## LDO & LSO GARAGE DOOR OPERATOR OPEN LIMIT SWITCH ADJUSTMENT

### **IMPORTANT BULLETIN - FIELD ACTION REQUIRED**

Adjusting the Open Limit on an LDO Operator

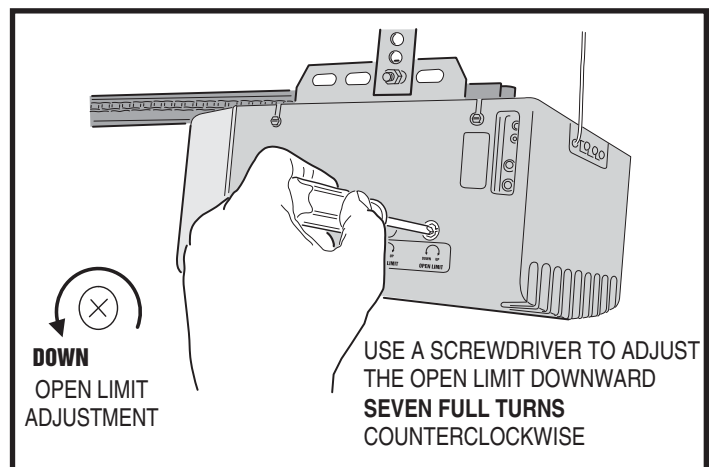
This bulletin applies to all Linear Model LDO & LSO garage door operators manufactured from December 3rd, 2007 to April 6th, 2008. Products manufactured between these dates have the preset factory location of the open limit adjustment set abnormally high. This can affect operator setup and testing in 7-foot and 8-foot rail installations.

If the open limit is not readjusted prior to testing the operator, with the trolley disconnected from the traveler (also known as the inner slide), it is possible to overrun the traveler into the drive sprocket during testing. This can cause damage to the traveler and/or the operator.

**To prevent possible damage to the operator and/or rail components, BEFORE APPLYING POWER TO THE OPERATOR, turn the OPEN LIMIT adjustment screw downward (counterclockwise) seven (7) full turns. This will return the operator to the normal factory setting. After adjusting, FOLLOW ALL PRINTED INSTRUCTIONS supplied with the operator.**
